Litwornia Associates has studied Streets and Parking

West Essex Highlands – Residential Application

To the West Orange Planning Board

West Essex Highlands – Application in West Orange Township, Essex County, NJ

Figure 1 - Existing Interior Private Roadways

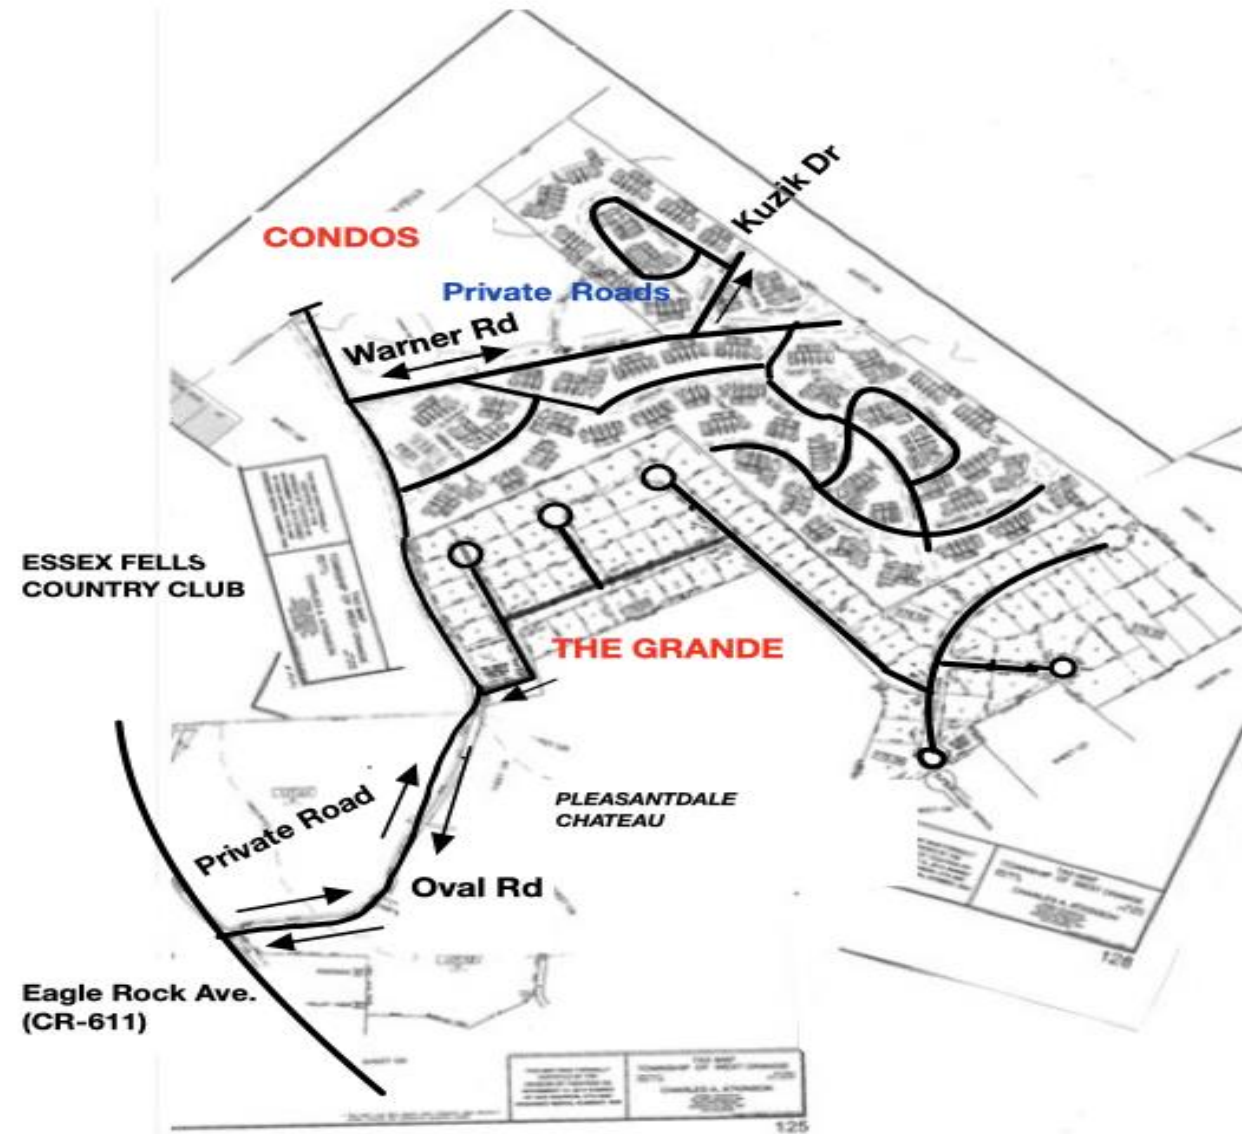
- RSIS ADT limits developers' development size:
- A Multiunit Cul-de-sac allows 1000 ADT, This application requires 2728 using RSIS factors, the existing 300 apartment units already use 1650 ADT plus the 72 single family homes contribute 727 more.
- The total above is 5105 which exceeds what minor collector roads are limited to at 3500 ADT and the Multiunit Cul-de-sac limit of 1000 ADT. This traffic load is all on Oval Road and Eagle Rock Ave intersection.
- Oval Road and Warner Roads are private, and those owners are not part of this application.
- Since Warner Road owners are not part of this application then this **application should not be considered** on a road the applicants do not own.

Tax Map 125
Eagle Rock –
Oval Road
existing
300 condos, 72
houses
current ADT
2377 trips

Figure 2 - Average Daily Trips (ADT)

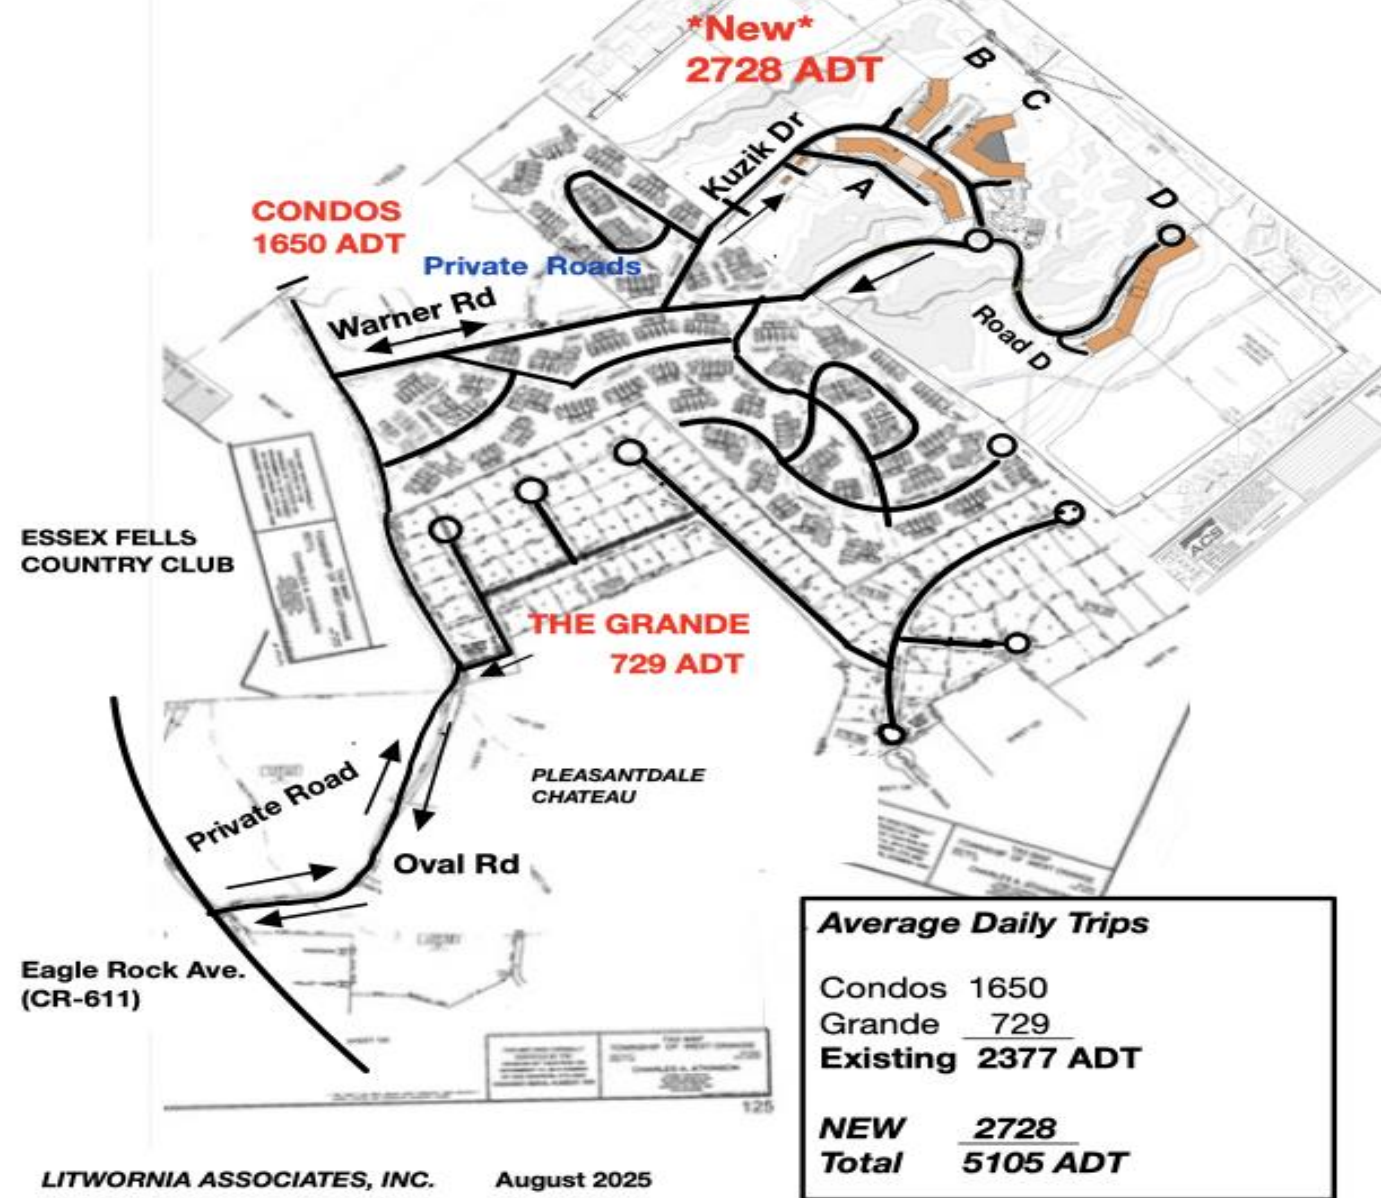
New
Additional 496
apartments
on Warner Rd
Future ADT
5105 trips

Existing (2377) + WEHI Proposed Development Total = 5105 ADT

Profile Warner Road – SP44

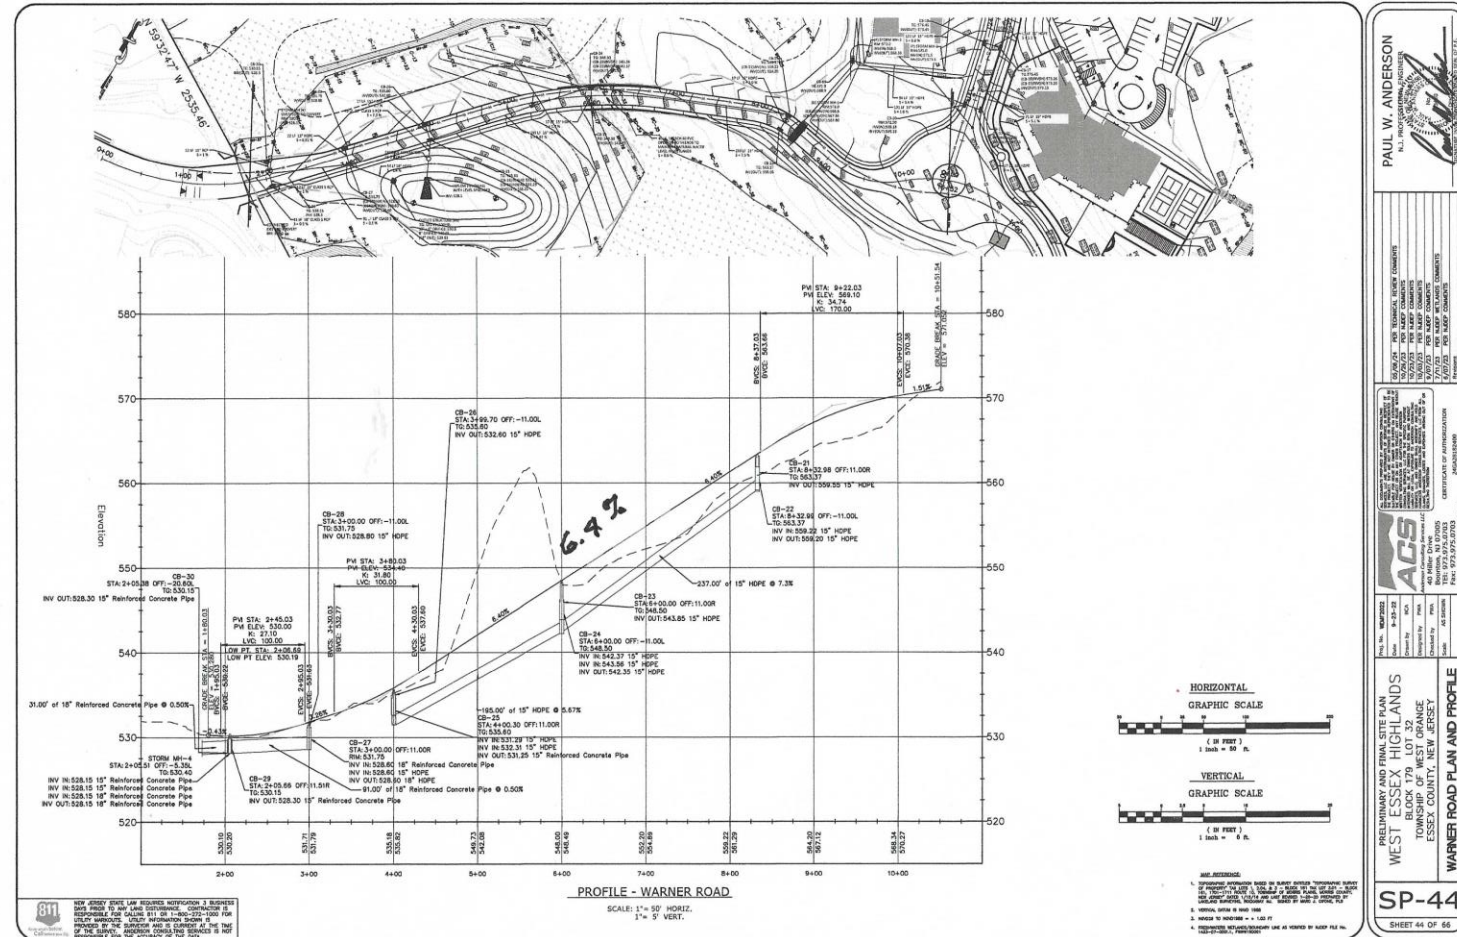
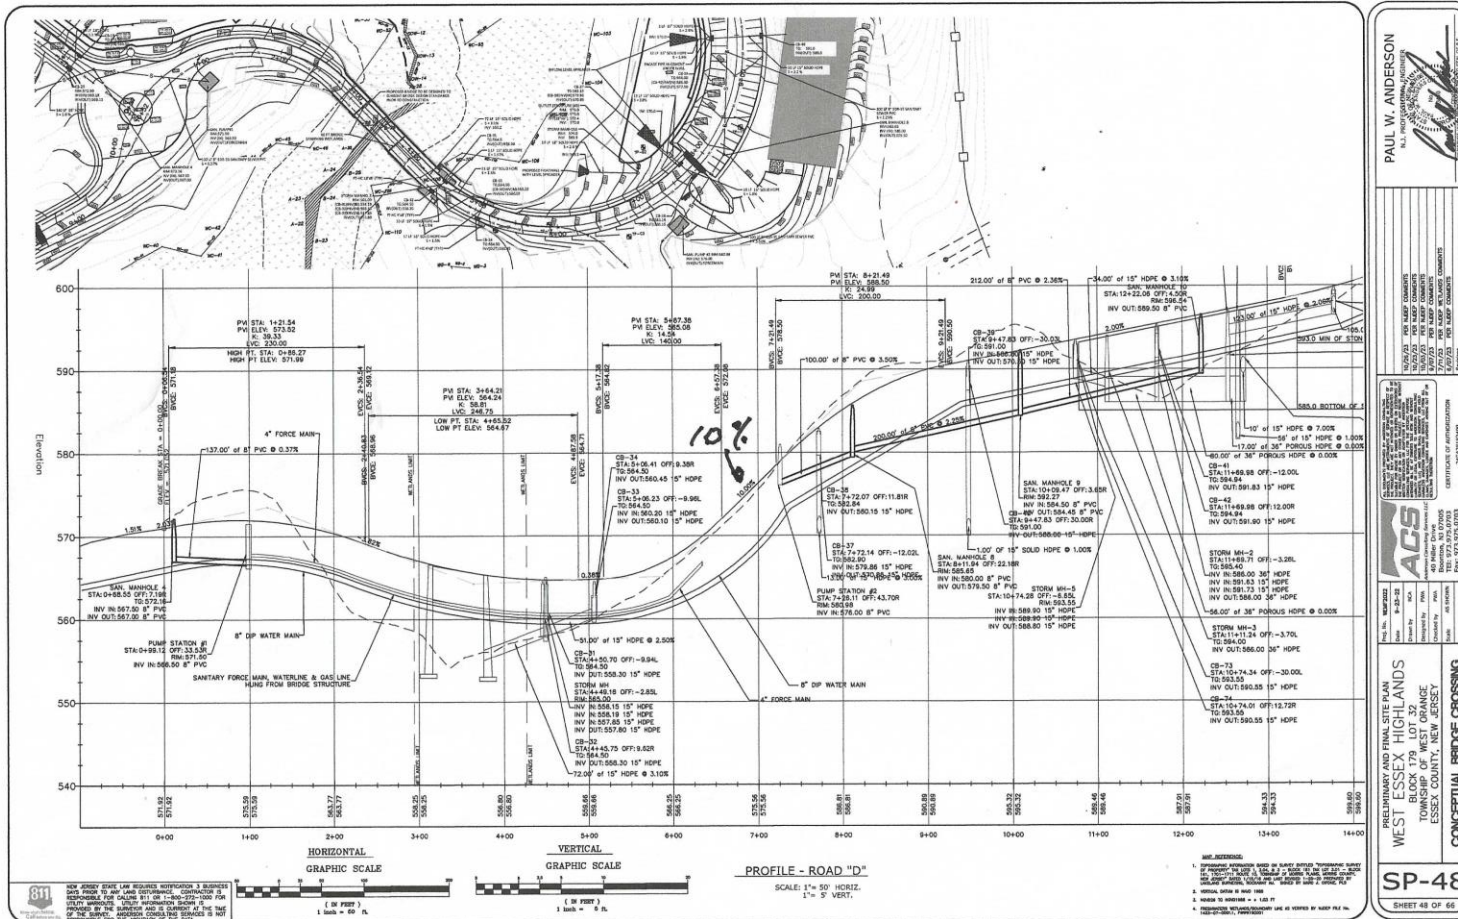
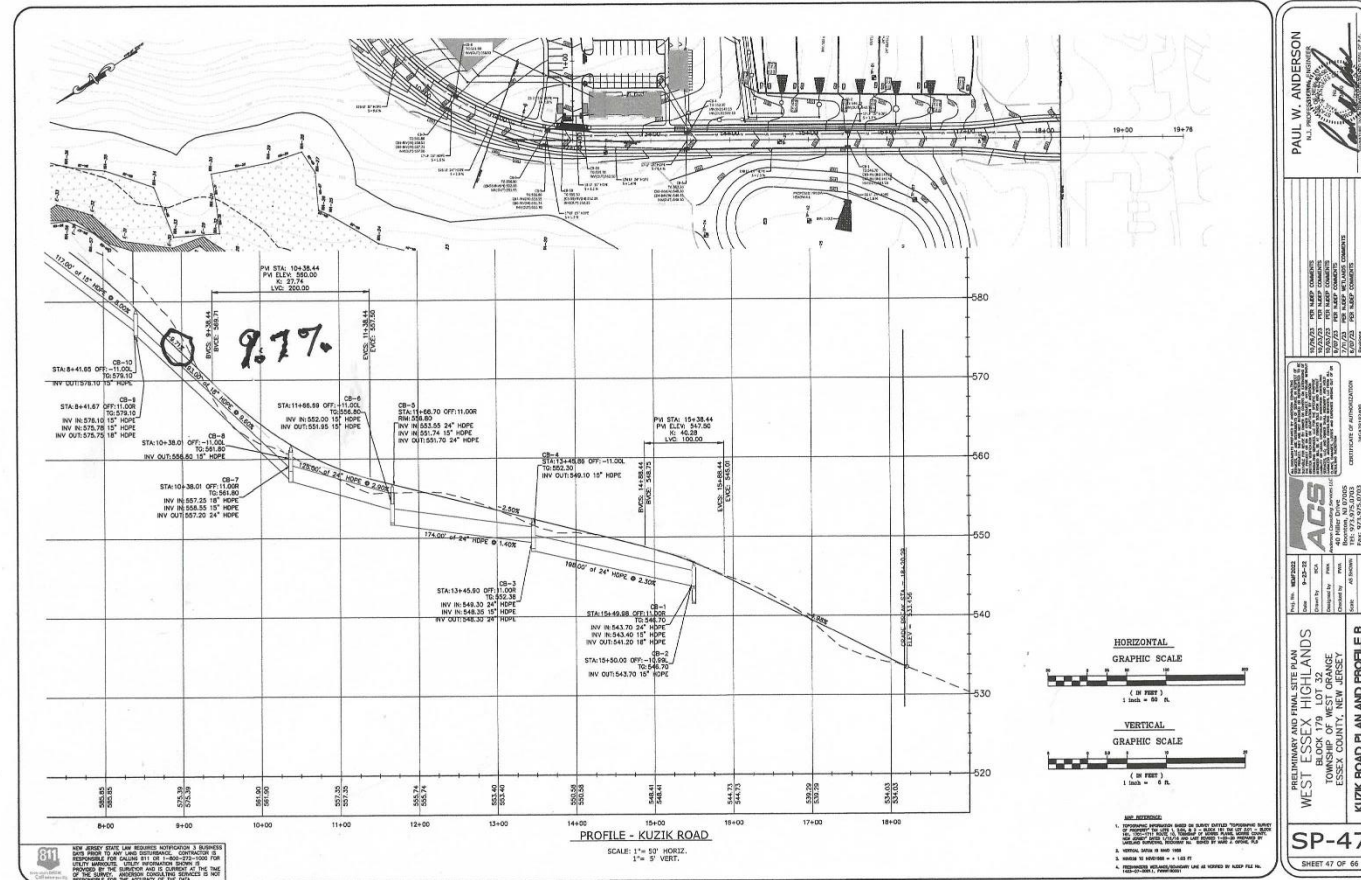
- Application shows non ADA compliant sidewalks on all streets
- Sidewalks on only one side in large portions of each street.
- Application shows 10% slopes far exceeding RSIS and ADA on large portions of each street.
- Sidewalks lack ADA required passing and turning width every 200'
- **Application exceeds the ADA rules by 100%.**
- **No De-minimus exceptions are allowed when above limits by 10% or more.**
- **See drawings to follow.....**
